Globus Garments Ltd.

Globus Garments Ltd., K.S. Complex, Mouchak, Kaliakoir, Gazipur, Bangladesh.
(+24.024055N, 90.294271E)

28th June 2014

Column Strength

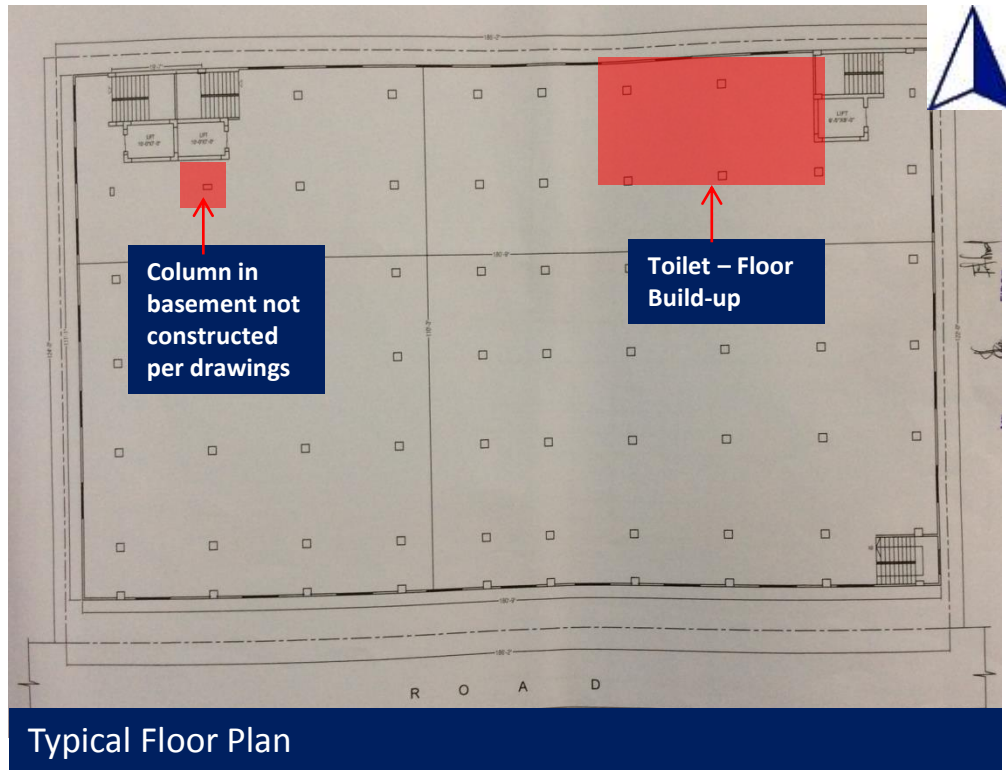
**Columns in the Factory Building (Building 1)
appear to be stressed in excess of normal
design limits and require immediate
review.**

Preliminary calculations indicate that columns generally within the factory building are stressed slightly in excess of normal design limits.

Immediate concern relates to columns which support floor build-up loads in the toilet area and to a single column at the north west side of the building, within the basement, which appears not to be constructed in accordance with the drawings.

Columns which appear to be highly stressed – Building Engineer to review immediately

Item No.	Observation	Recommended Action Plan	Recommended Timeline
1	Columns in the Factory Building (Building 1) appear to be stressed in excess of normal design limits and require immediate review between Basement and 3rd floor level.	Building Engineer to review design, loads and column stresses in columns throughout the building from basement to 3rd floor. Prioritise review of columns which support floor build-up loads in the toilet area and single column at the north west side of the building, within the basement, which appears not to be constructed in accordance with the drawings.	Immediate - Now
2	Columns in the Factory Building (Building 1) appear to be stressed in excess of normal design limits and require immediate review between Basement and 3rd floor level.	Verify insitu concrete stresses either by 4 No 100mm diameter cores or existing cylinder strength data. Reinforcement quantities also to be confirmed.	Immediate - Now

Typical Floor Plan Main Factory Building

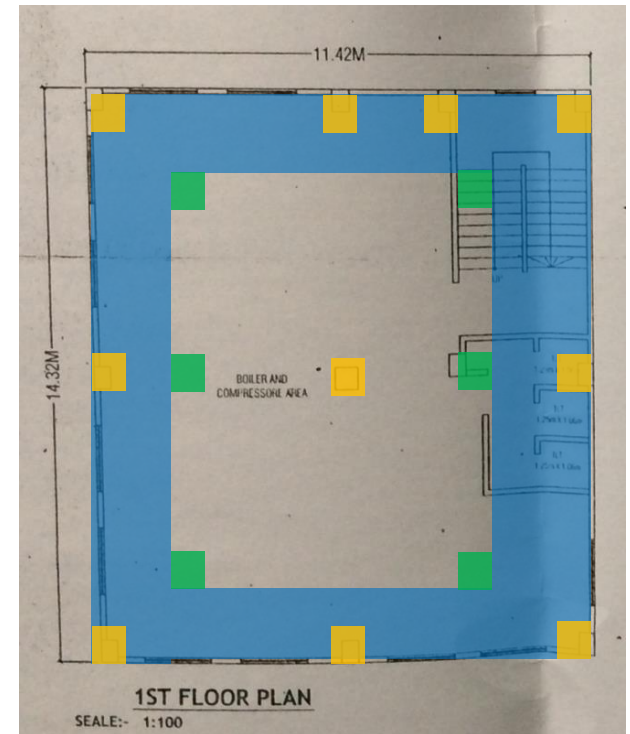
Undersized column at basement level

Incorrect column locations – no column at this location

Actual column locations

Item No.	Observation	Recommended Action Plan	Recommended Timeline
5	Design check required due to irregularities in design documentation	Building Engineer to commence a design check to assess the safety and serviceability of the building with reference to discrepancies between the drawings and as constructed Factory Building and Utility Building.	Immediate - Now
6	Design check required due to irregularities in design documentation	Building Engineer to survey all areas of the buildings, collect information and prepare a full and accurate set of “as-constructed” drawings.	6-weeks
7	Design check required due to irregularities in design documentation	Building Engineer to complete design check on the safety and serviceability of the buildings.	6-weeks
8	Design check required due to irregularities in design documentation	Building Engineer to implement any actions / supervise any remedial works as identified following the design check.	6-months

Utility Building – Permit Layout

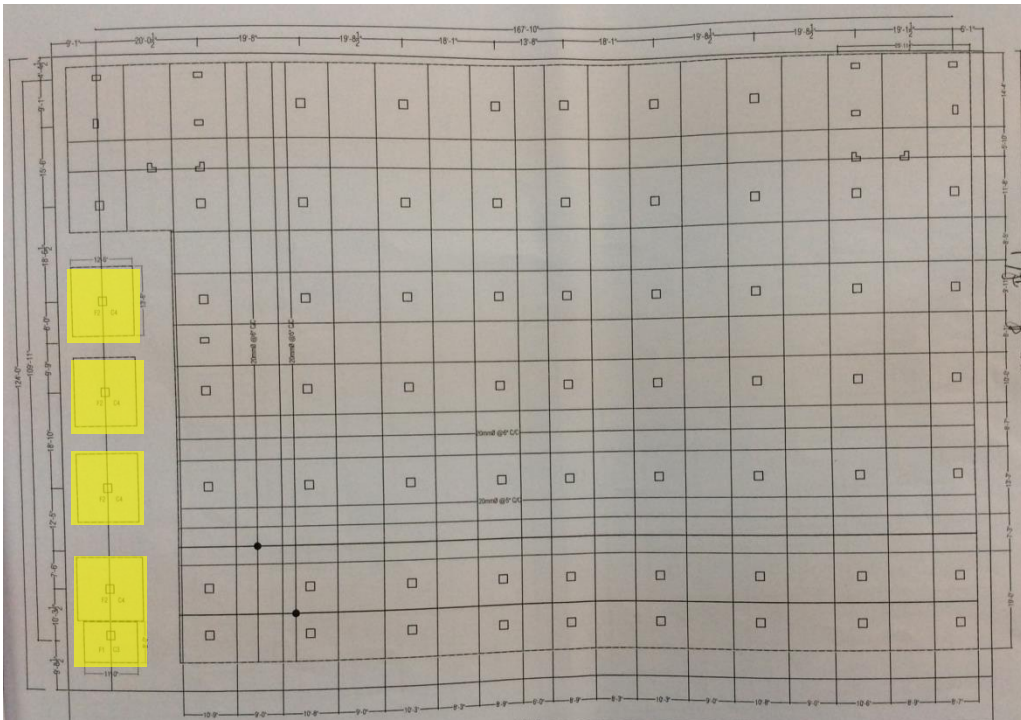
Cantilevers not shown on drawing

Building 2 – Utility Building – Cross section

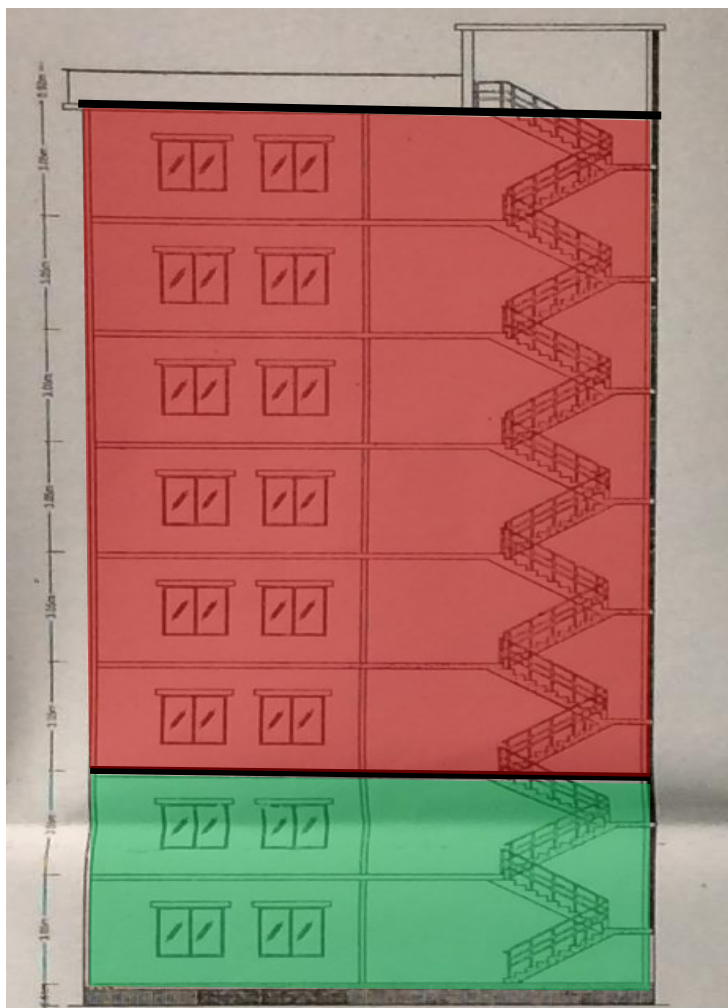
Utility Building (Building 2) has LGED-approval for eight-storeys. There are important differences between the design drawings and the as-built structure. Building Engineer to review structural design and concrete strength within existing columns prior to construction of any further building extension above the existing two storeys.

9	All proposed additions to the existing Utility Building (Building 2) structure, including additional storeys as permitted, are to be reviewed by the Building Engineer	For all proposed additions to the Utility Building (Building 2) structure, Building Engineer to carry out a design check to assess the safety and serviceability of the building, particularly in relation to column sizes and lateral stability, taking into account the additional loads.	6-months
10	All proposed additions to the existing Utility Building (Building 2) structure, including additional storeys as permitted, are to be reviewed by the Building Engineer	In-situ concrete testing to be carried out as part of any future structural assessments.	6-months
